ORIGINATION FORM

Proposed Revisions to a Standard Plans Index
(Please provide all information — Incomplete forms will be returned)

Index Number: 102-603
Sheet Number (s): 3
Index Title: Two-Lane, Two-Way, Work Within the Travel Way

TWO-LANE, TWO-WAY, WORK WITHIN THE TRAVEL WAY

INDEX	SHEET
102-603	1 of 3

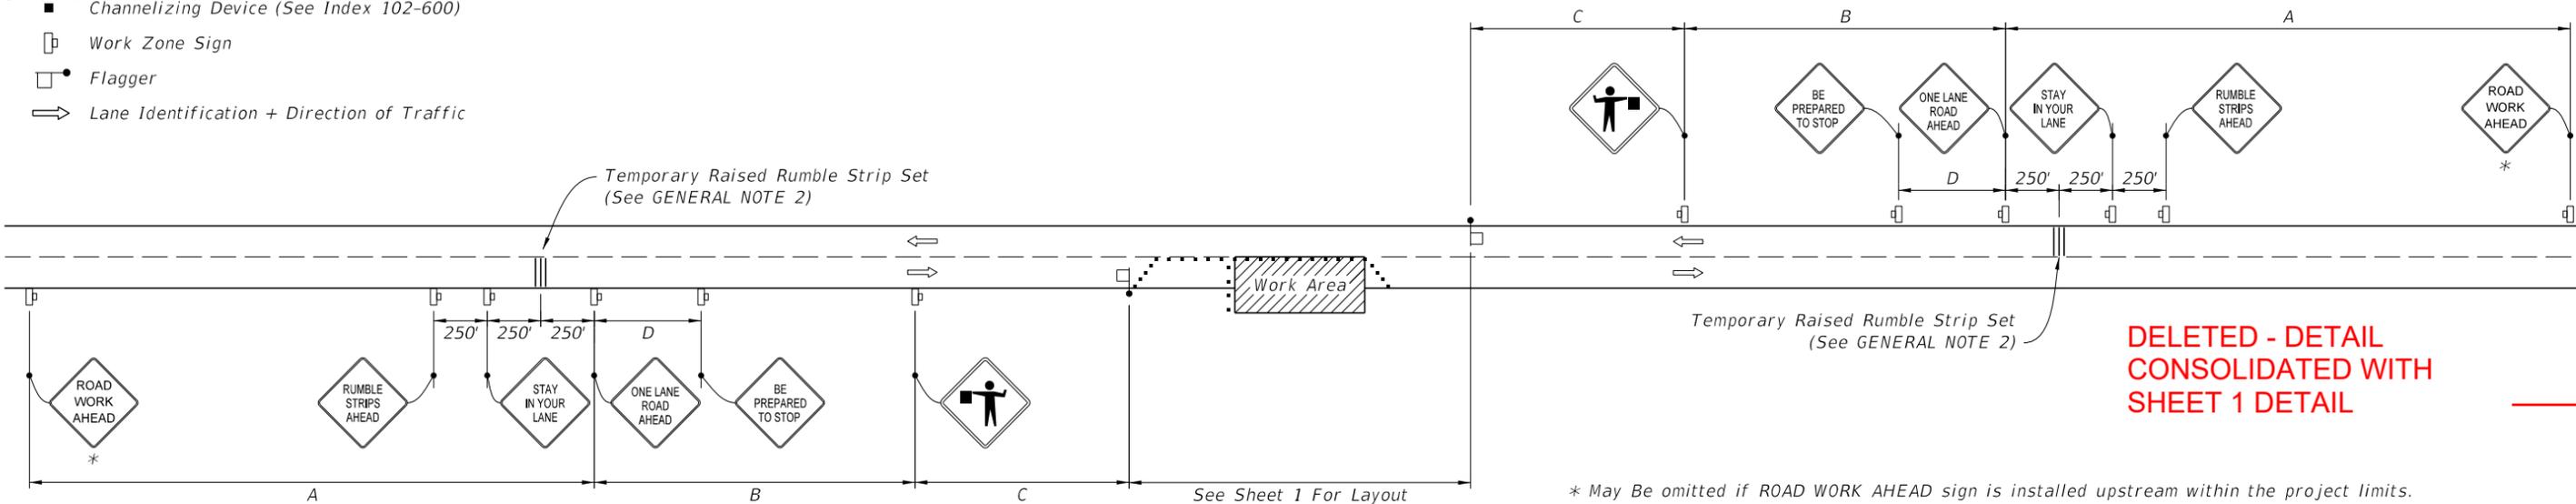
REVISED DETAIL - CONSOLIDATED WITH SHEET 2 DETAIL

REVISED NOTES

DELETED - MOVED TO 102-600

~~CONDITIONS WHERE ANY VEHICLE, EQUIPMENT, WORKERS OR THEIR ACTIVITIES ENCROACH THE AREA BETWEEN THE CENTERLINE AND A LINE 2' OUTSIDE THE EDGE OF TRAVEL WAY.~~

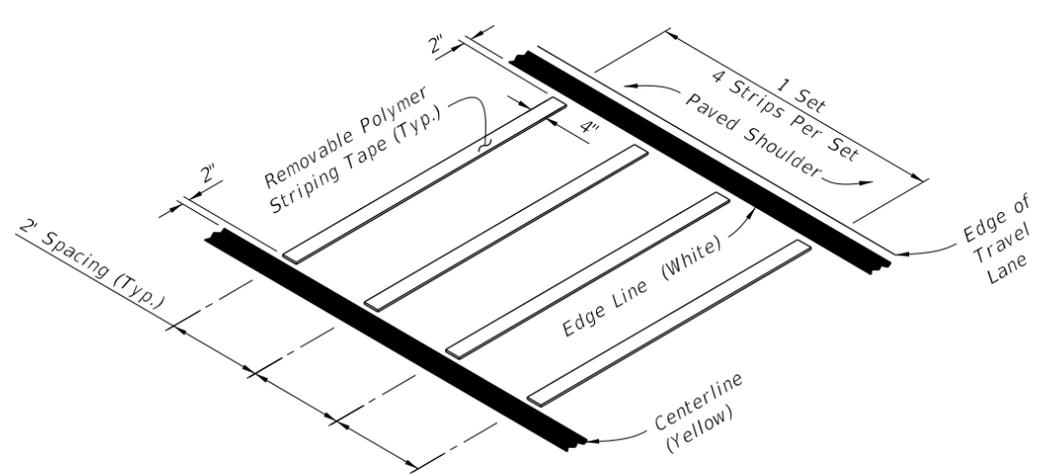
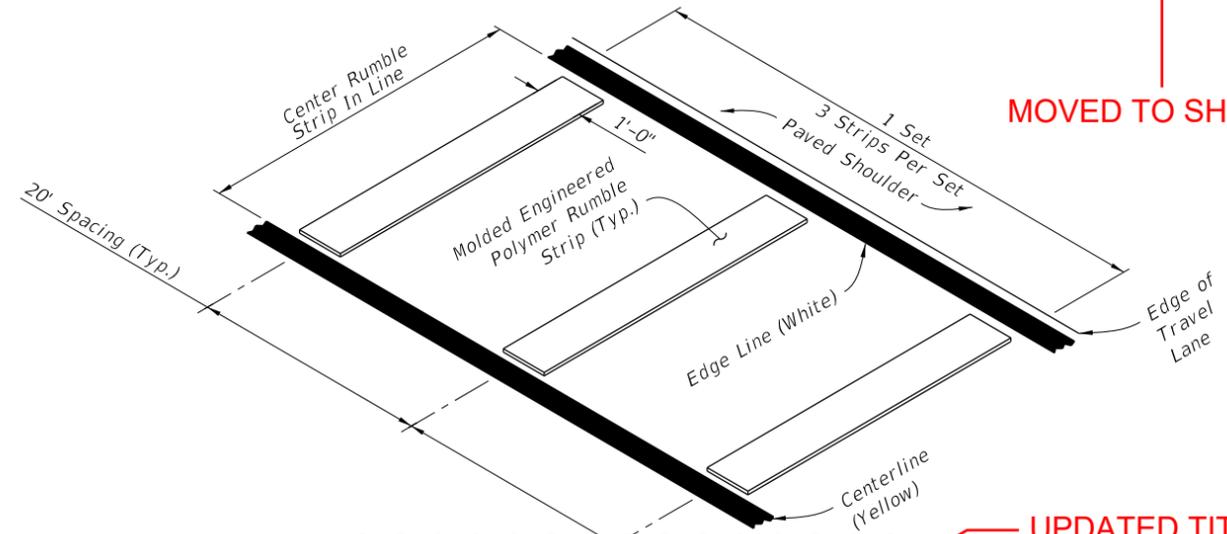
MOVED TO SHEET 1

LAST REVISION 11/01/17	REVISION 11/01/20	DESCRIPTION: 11/01/20		FY 2020-21 2021-22 STANDARD PLANS	TWO-LANE, TWO-WAY, WORK WITHIN THE TRAVEL WAY	INDEX 102-603	SHEET 3 of 3
---------------------------	----------------------	--------------------------	--	---	--	------------------	-----------------

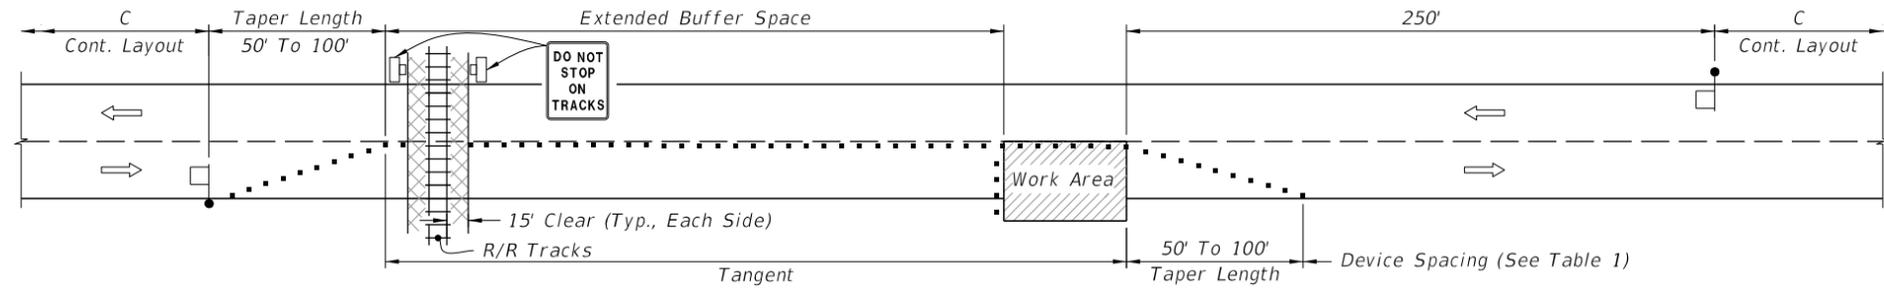
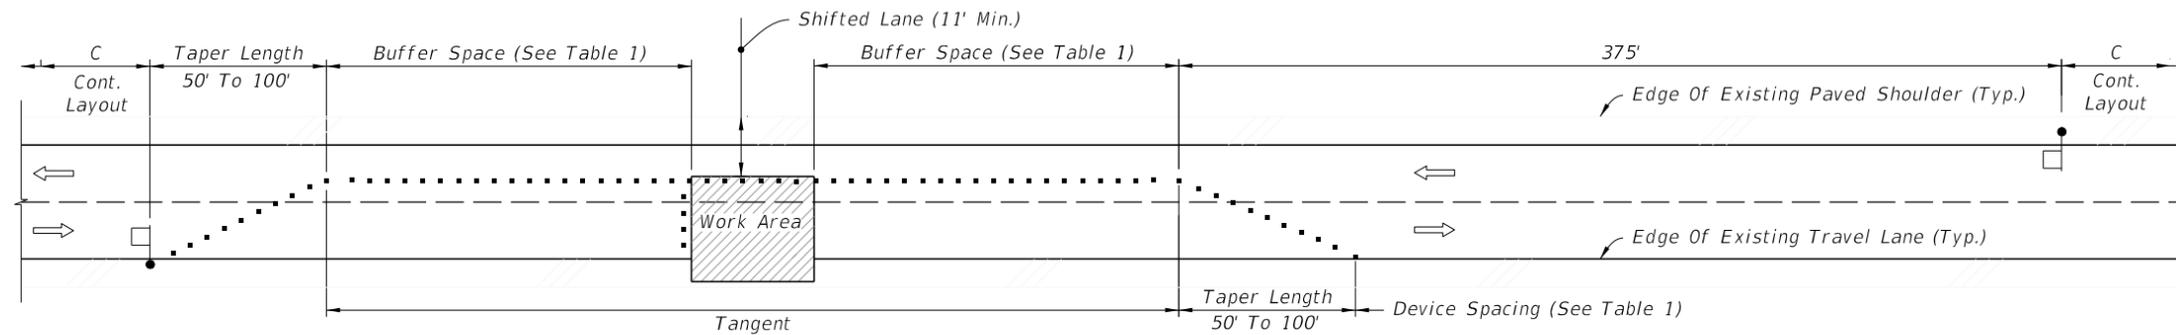
DELETED SHEET

REVISED DETAILS
AND MOVED TO
SHEET 2

LAST REVISION 11/01/20	REVISION	DESCRIPTION:	 FY 2021-22 STANDARD PLANS	TWO-LANE, TWO-WAY WORK WITHIN THE TRAVEL WAY	INDEX 102-603	SHEET 1 of 2
---------------------------	----------	--------------	----------------------------------	---	------------------	-----------------

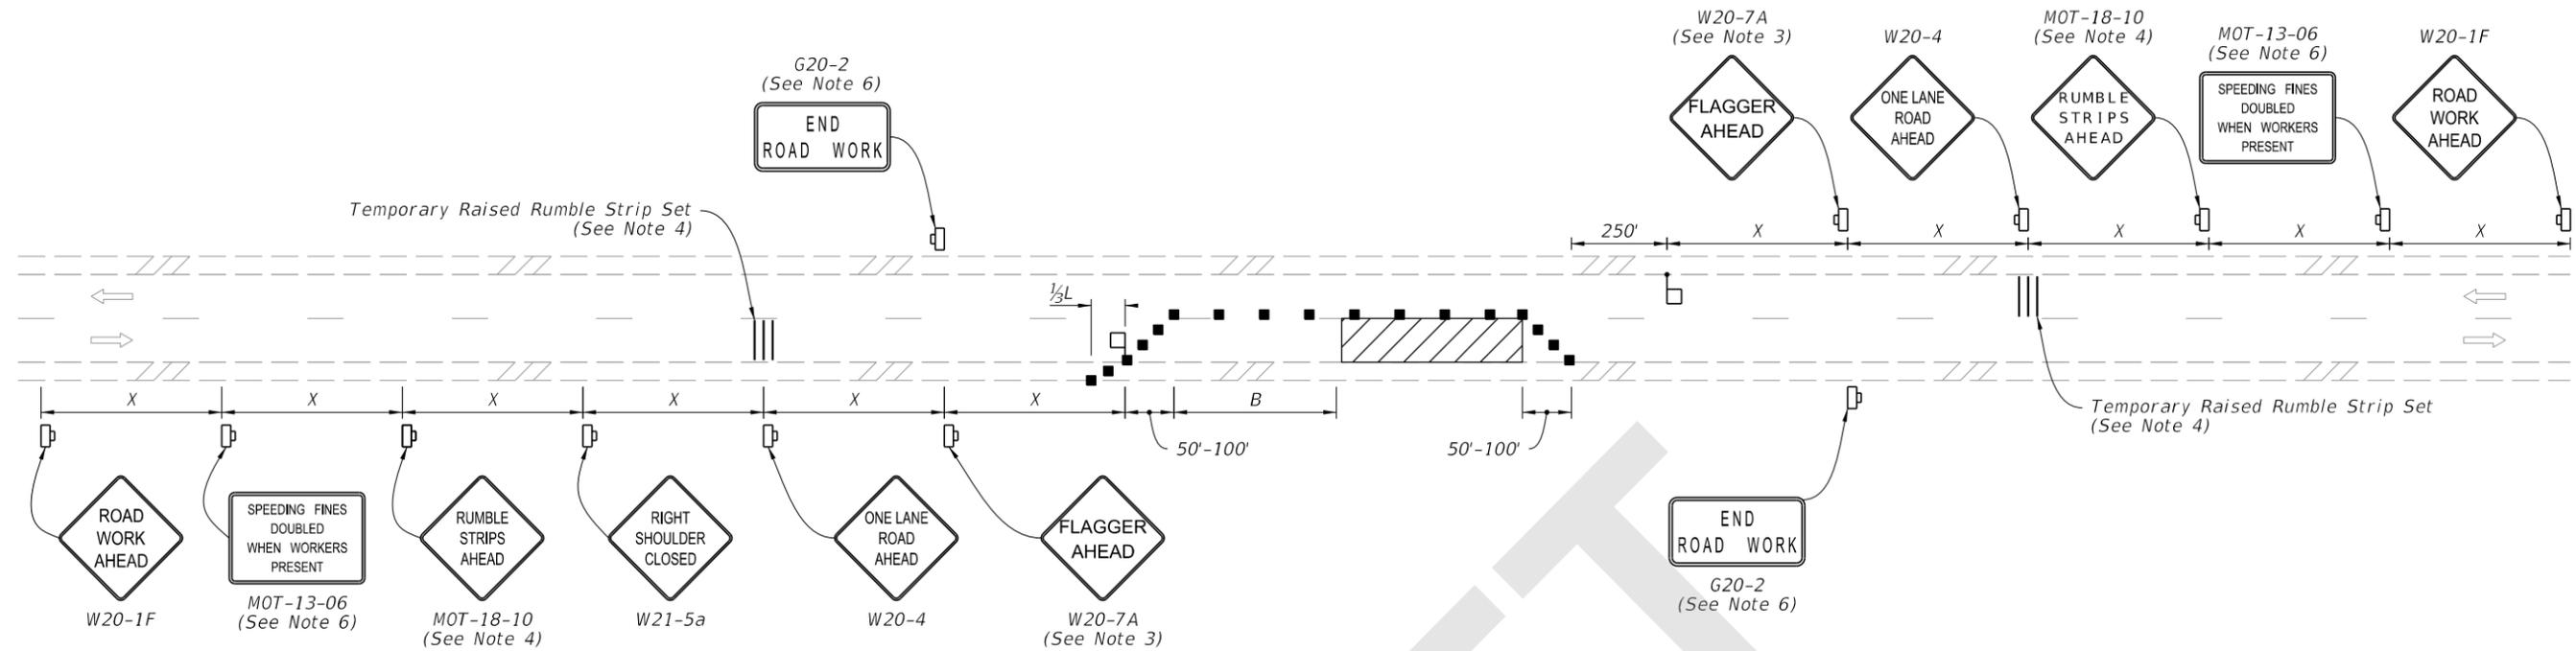
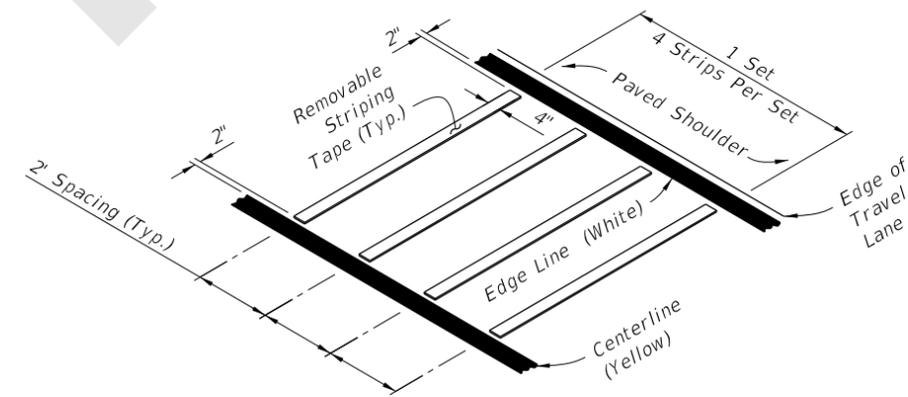
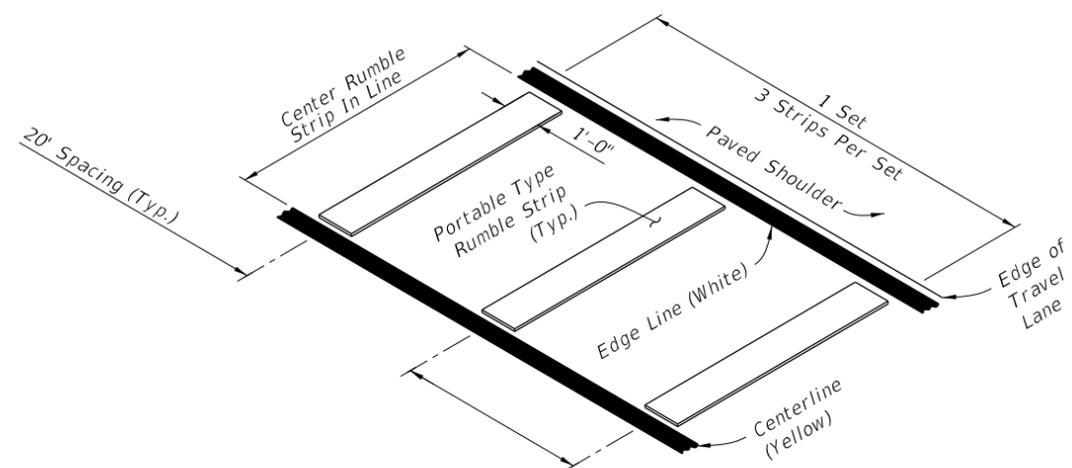
- Sheet 1: Consolidated Detail with Sheet 2 Detail and Revised; Revised General Notes; Deleted Table 1 (Moved to 102-600); Deleted 'Conditions'.
- Sheet 2: Consolidated Detail with Sheet 1 Detail and Moved to Sheet 1; Updated Rumble Strip Set Titles; Added and Revised 'Special Conditions' Details from Sheet 3.
- Sheet 3: Relocated 'Special Conditions' Details to Sheet 2 and Deleted Sheet.
